Application Number **P25-09**

P25-09 **Wadsworth Road Residential Development**

Property Owner: 57 South LLC
Applicant: Tim Pelton
Location: 1011 Wadsworth Road
Zoning: R-4 (Multi-Family Residential)
Request: Site Plan approval for an attached single-family and detached single-family residential development

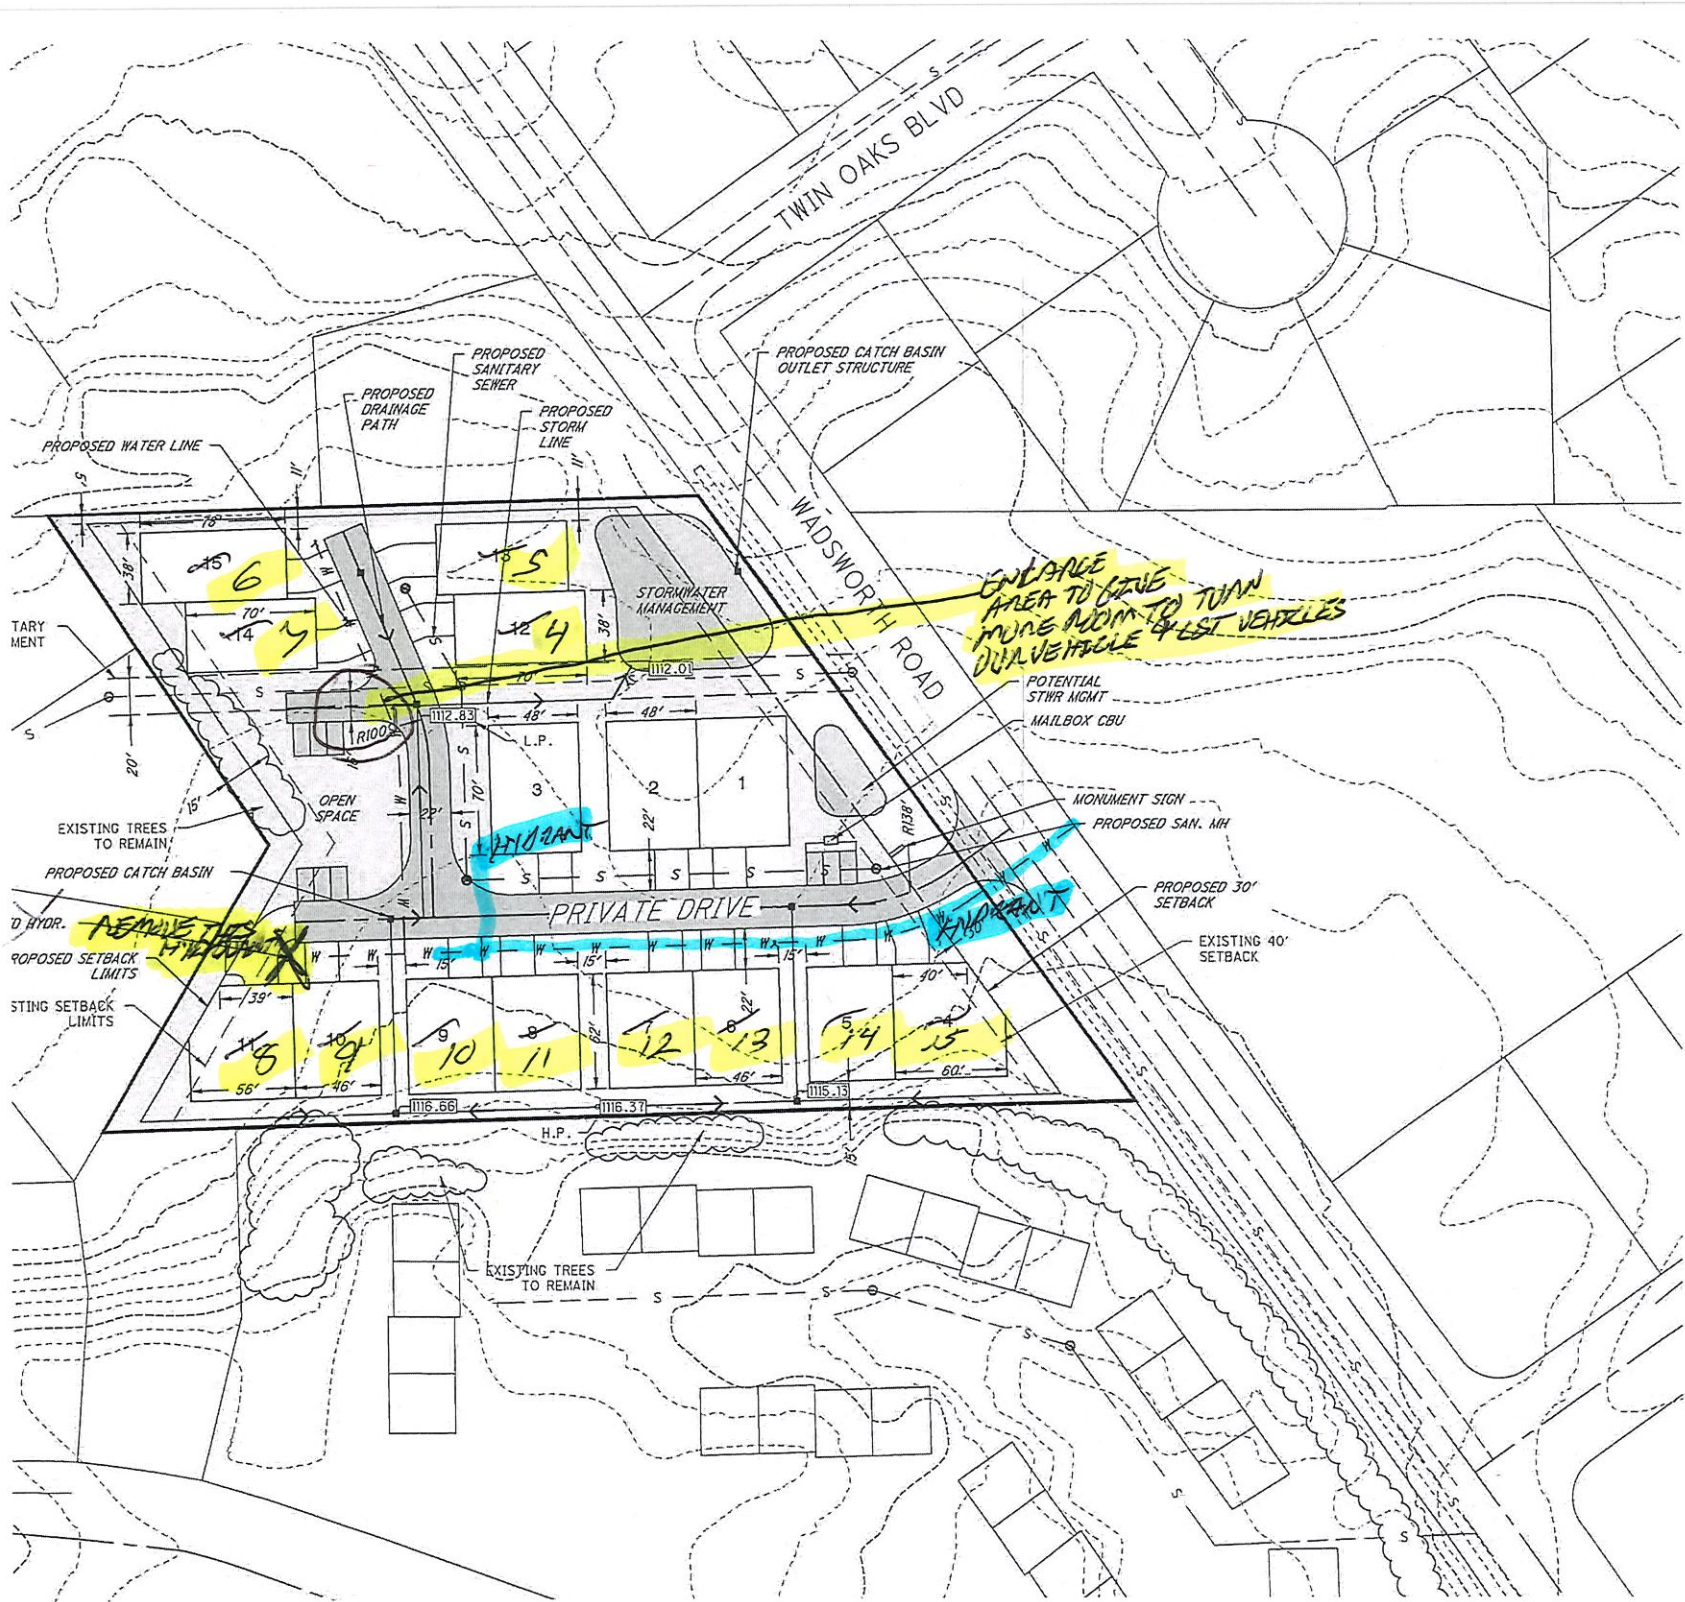
- 1) To help police, fire and ems to easily locate buildings, the building numbering should be as follow:
Buildings 1, 2 & 3 numbers should remain as shown, continuing counter clock wise building 12 should be 4;
13 should be 5; 15 should be 6; 14 should be 7; 11 should be 8; 10 should be 9; 9 should be 10; 8 should be 11;
7 should be 12; 6 should be 13; 5 should be 14 and 4 should be 15.

- 2) Locate a fire hydrant either in front of or before the building currently marked number 4, also add a fire hydrant on the street side at the corner of building number 3 and remove the proposed hydrant which is located at the end of the private drive.

- 3) Since a revised drawing show the private drive as being 24 feet wide only the fire hydrant side of the street will need to posted as NO PARKING. If the drive that runs north and south is to remain as 22 feet wide then both sides of that street will need to be posted as NO PARKING. If they increase that street width to 24 feet then only the fire hydrant side will need to be posted as NO PARKING.

- 4) The T-turn around for the north/south running drive need the radius increased to allow for fire and ems to easily back their vehicles when using the turn around.

I have attached a drawing which corresponds with my comments.
